Sub Region RTEP Mid-Atlantic Committee DPL Supplemental Projects

October 15, 2020

DPL Transmission Zone M-3 Process

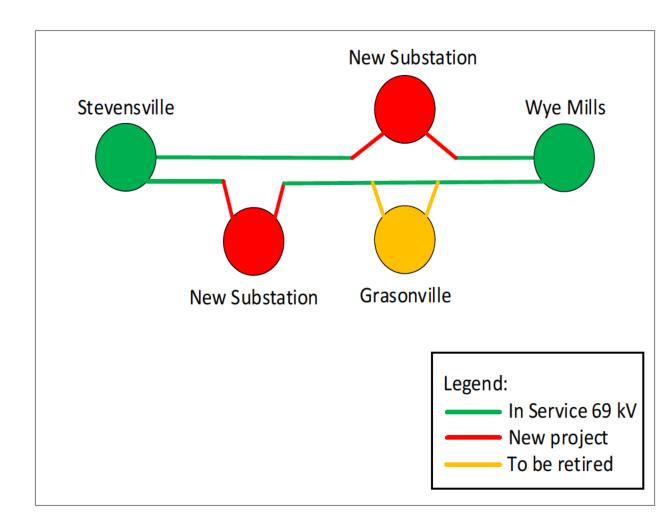
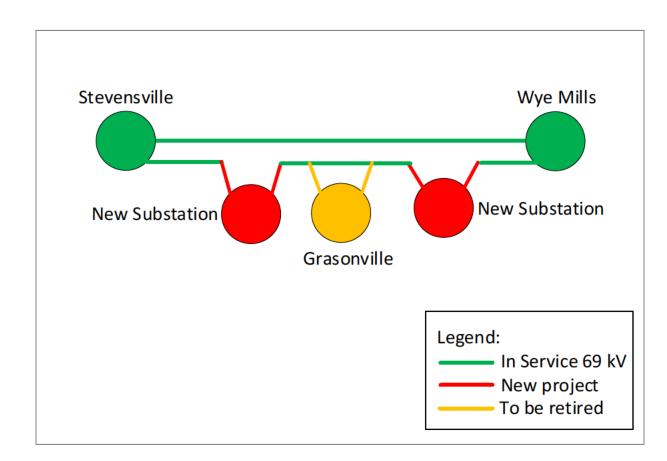
Original Proposed Solution: (see next slide for the new/updated solution)

- Construct new 4-breaker ring bus substation west of existing Grasonville Substation on Grasonville to Stevensville 69 kV line.
- Construct new 4-breaker ring bus substation west of existing Wye Mills Substation on Wye Mills to Stevensville 69 kV line.
- Retire existing Grasonville Substation.
- Estimated Cost: \$13.5M

Revised Proposed Solution:

- Construct new 5-breaker ring bus substation west of existing Grasonville Substation (w/30MVAR Capacitor Bank)
- Construct new 5-breaker ring bus substation west of existing Wye Mills Substation (w/30MVAR Capacitor Bank)
- Retire existing Grasonville Substation.
- Estimated Cost: \$18.5M
